IN THE MATTER of proposed Plan Change G: Aokautere Urban
Growth to the Palmerston North City Council
District Plan

**STATEMENT OF REPLY EVIDENCE OF ANDREW BURNS ON BEHALF OF PALMERSTON NORTH
CITY COUNCIL**

URBAN DESIGN

Dated: 28 November 2023

Attachment A - PCWL Plan Change B – Outline Development Plan by ProArch

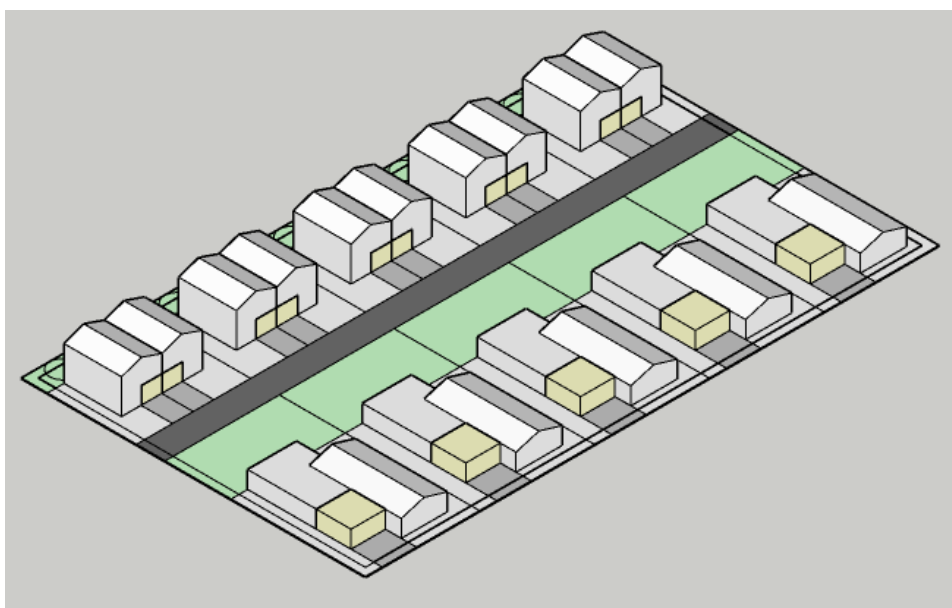
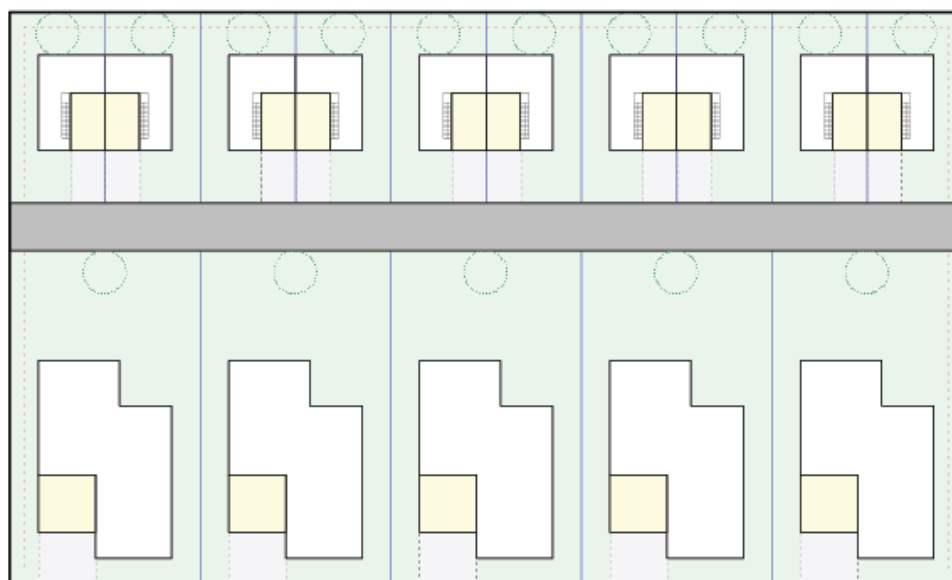
- [35] My s 42A Report provides a city-wide contextual diagram indicating approximate distances 'as the crow flies' of various growth areas to The Square.¹⁶ This is simply meant to provide a geographical reference to locate Aokautere within its city-wide context. I indicate that the central point of Aokautere lies on a 6km radius if drawn from The Square. I have double-checked the distance between The Square and the proposed Aokautere Local Centre using Council's online GIS tool, measuring the distance if following roads, and confirm a distance of 6km. I have compared this to the distance from The Square to the commercial and medium density part of PCWL's Plan Change B (5km-5.4km) at Kākātangiata (refer to **Attachment A**). Therefore, the Aokautere Local Centre and adjacent medium density housing is approximately 1km further from The Square than the example referred to by the submitter.

Attachment B – Medium Density Testing on typical 6,000sq.m block

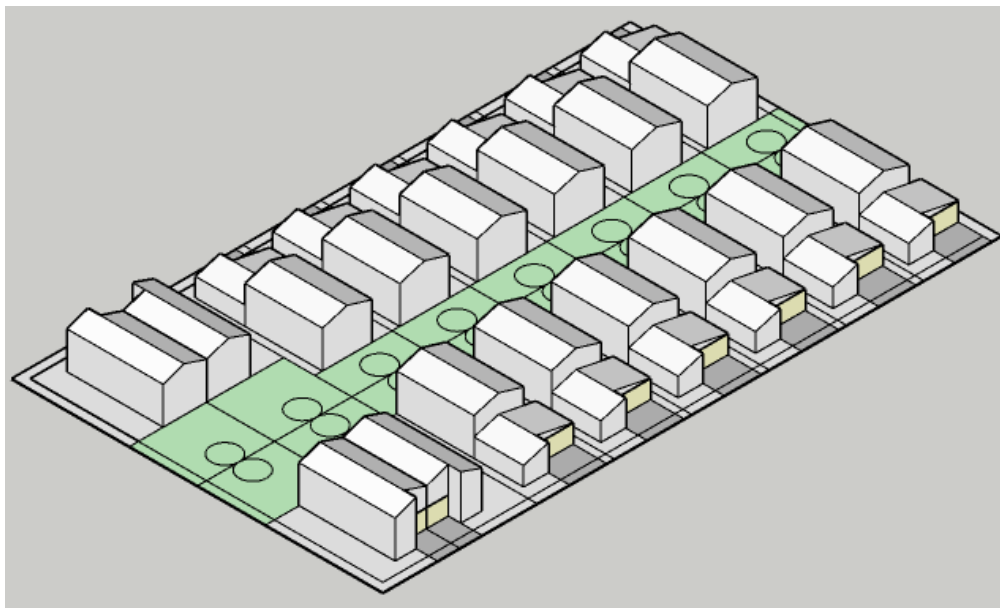
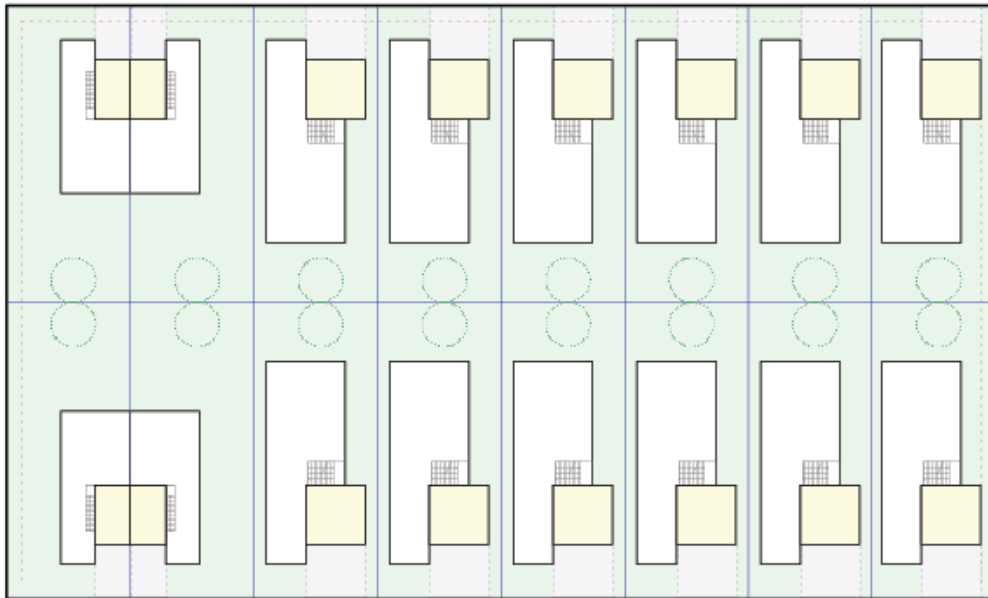
[66] Minimum density is the issue, not maximum yield possible within the medium density area. Minimum medium density development at Aokautere has been set low (25 DPH net) that does not force intense terraced or apartment type housing but is a transitional density that allows a combination of semi-detached and fully detached dwellings on smaller lots in the medium density zone. This is a much less 'directed' outcome and I suspect submitters have not fully tested the prescribed density level but are reacting to the term 'medium density'. At **Attachment B** I provide a series of studies that demonstrate what a range of densities look like, including the lowest 25DPH outcome and ranging up to 51DPH and 63DPH. These indicate flexibility remains at the scale of individual lots and outcomes can be varied as part of future resource consents.
